RE: Summary of Site Assessment Data for 701 San Pablo Avenue in Albany, California

Re: Required investigations at 701 San Pablo Avenue, Albany, California

Figure 3. Soil Sampling Locations

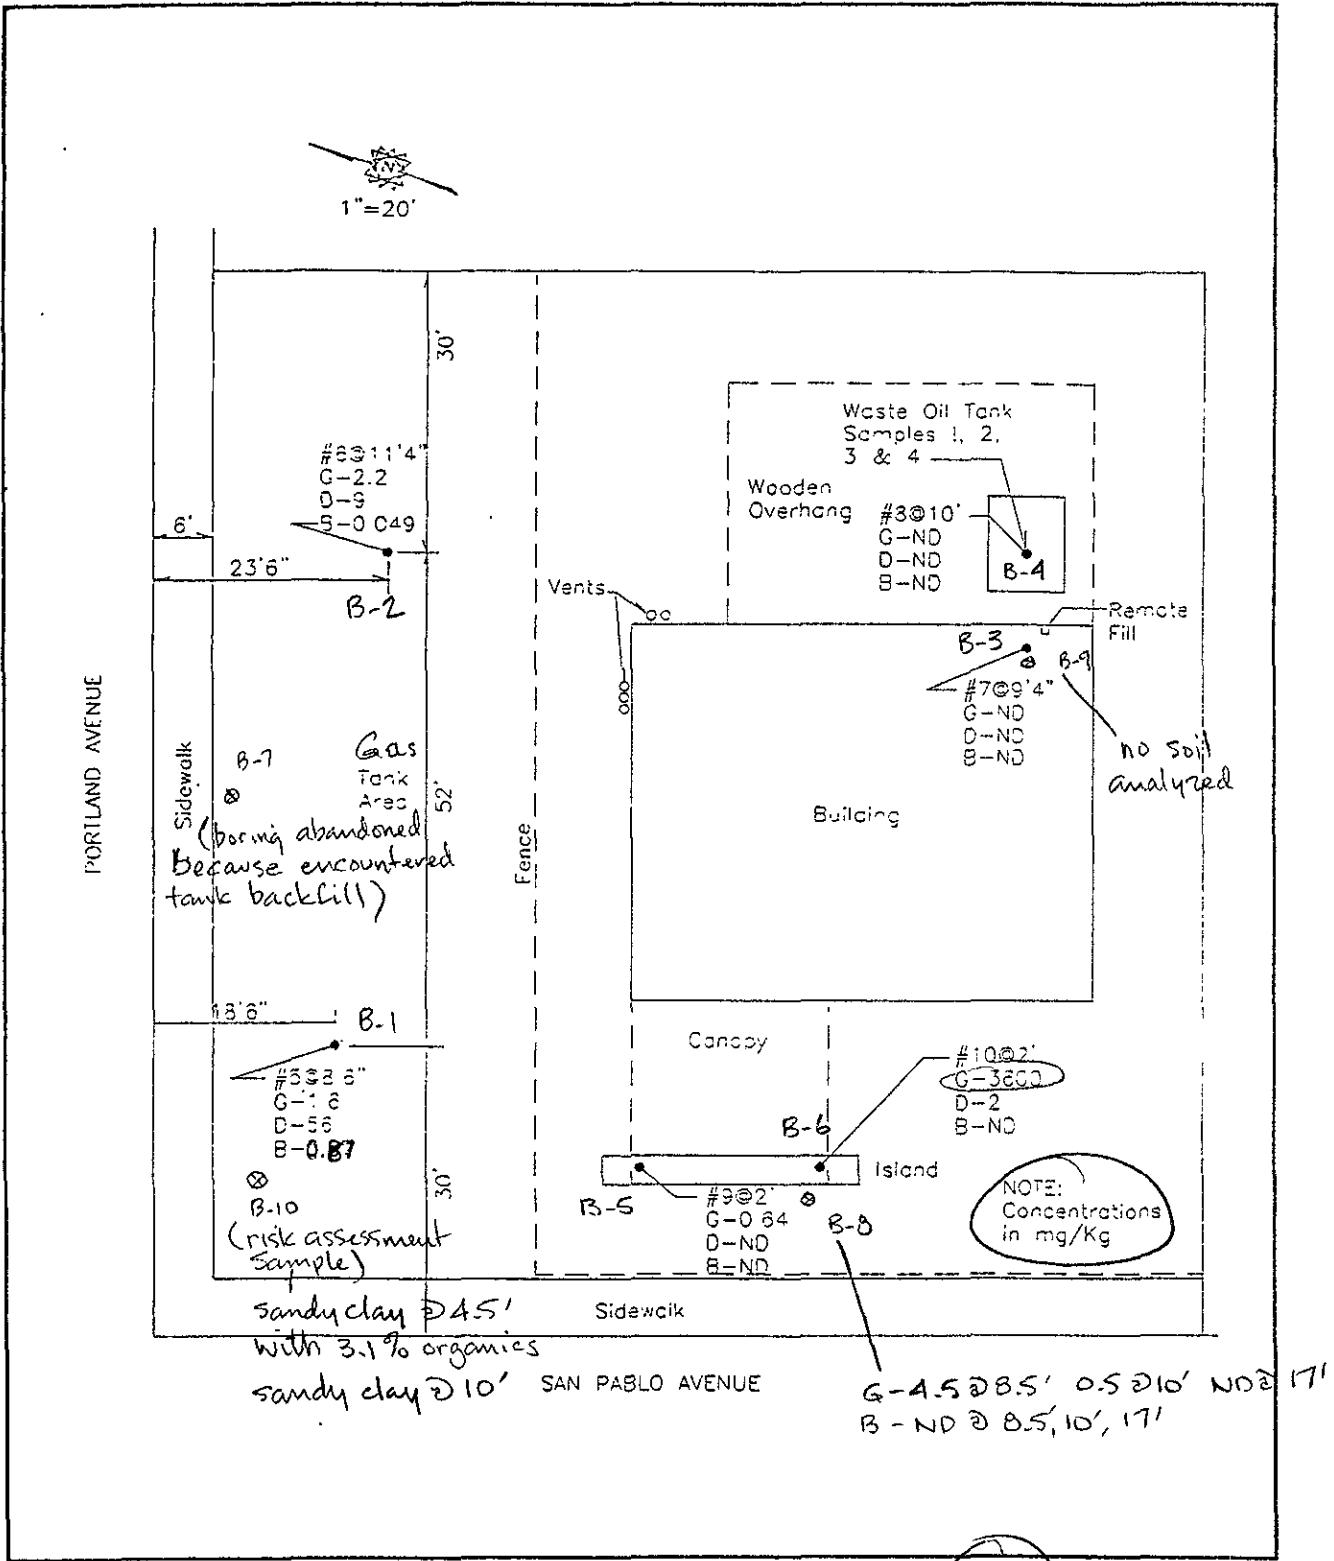
- ? Date of these samples (May/June 1997)
- ? If they did not file for reimbursement, how does that affect our oversight
- ? what were results from B10
- Looks like ① gw sample only from BB
- ?--soil sample from bottom of wo pit after over-excavation? ~~PH~~
- what about stockpiles--still there.

They plan to: ① over excavate wo pit to 10' to remove any possible cont.
② " " soil at dispenser area w/ confirmatory
③ doing a boring w/ litho info - N of tank pit - since B-7 was not successful

Figure 4. Groundwater Sampling Locations

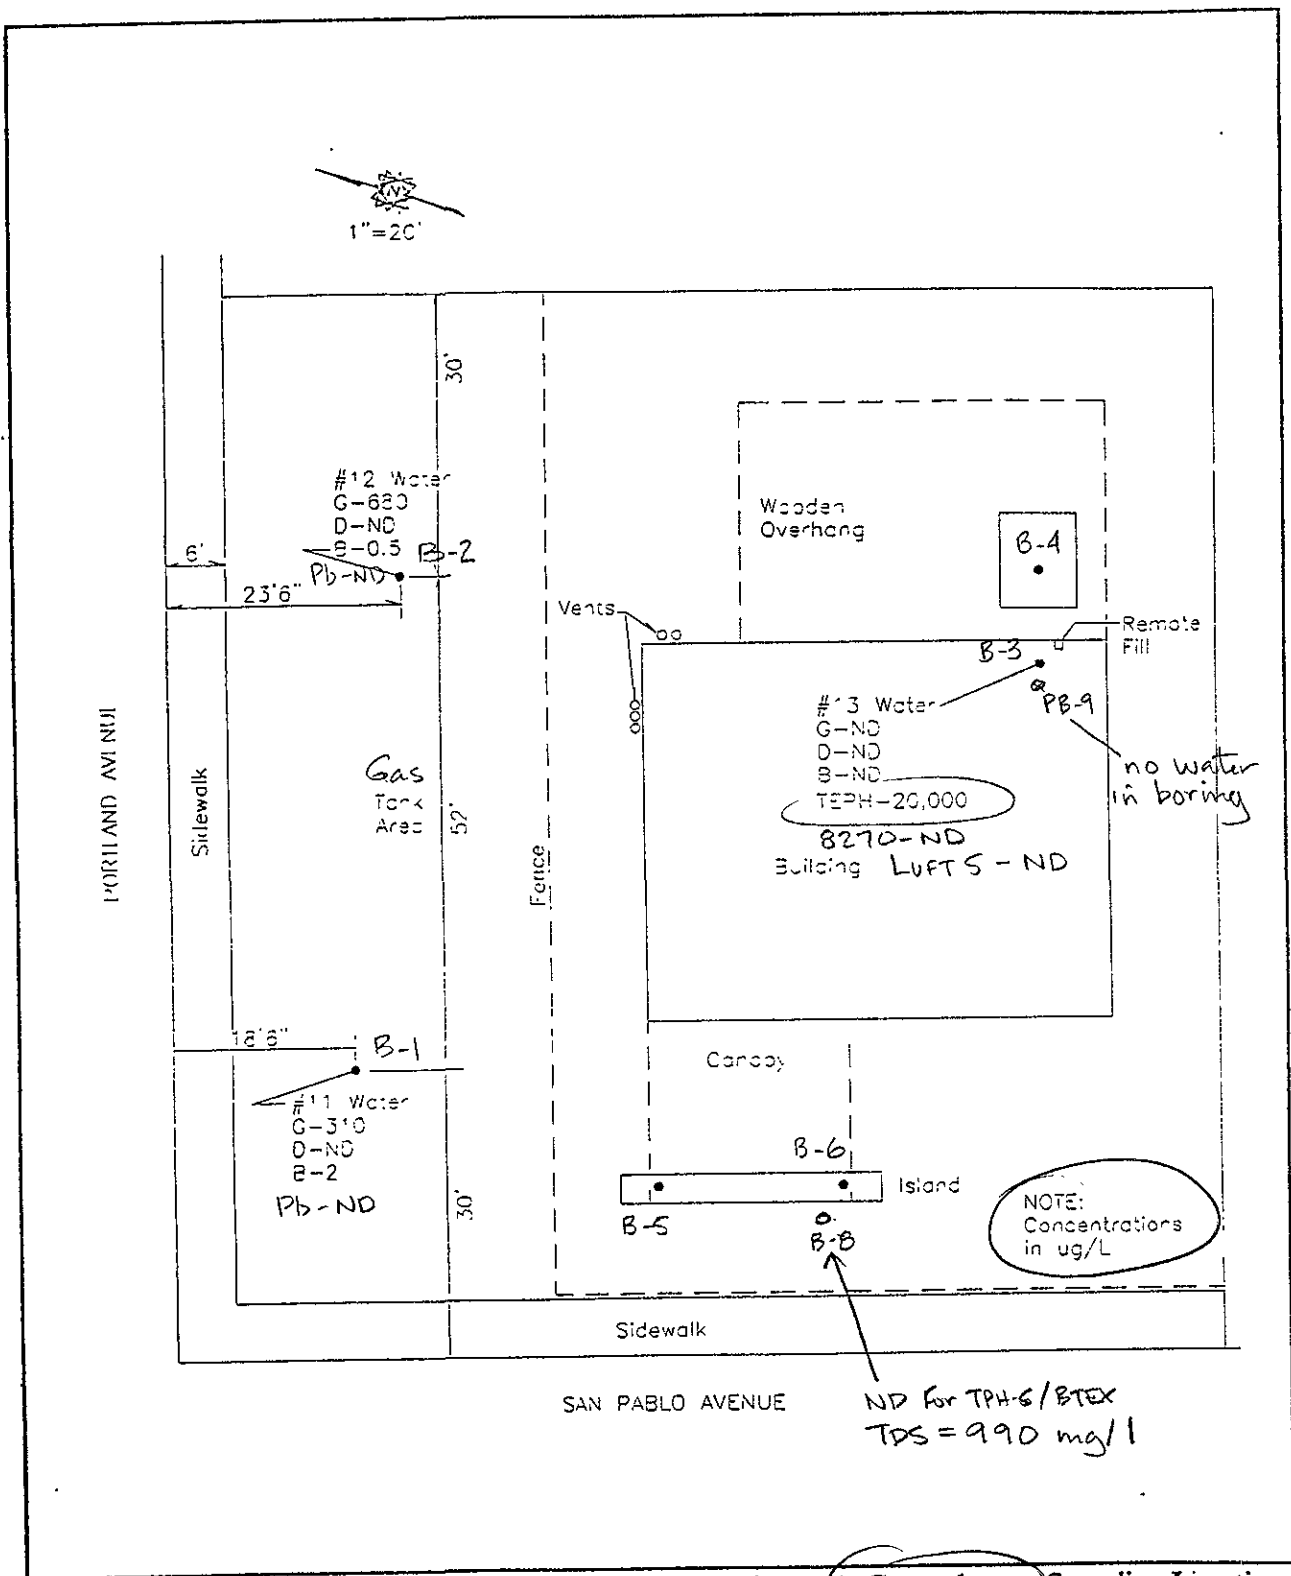
- 20,000 ppb TEPH?
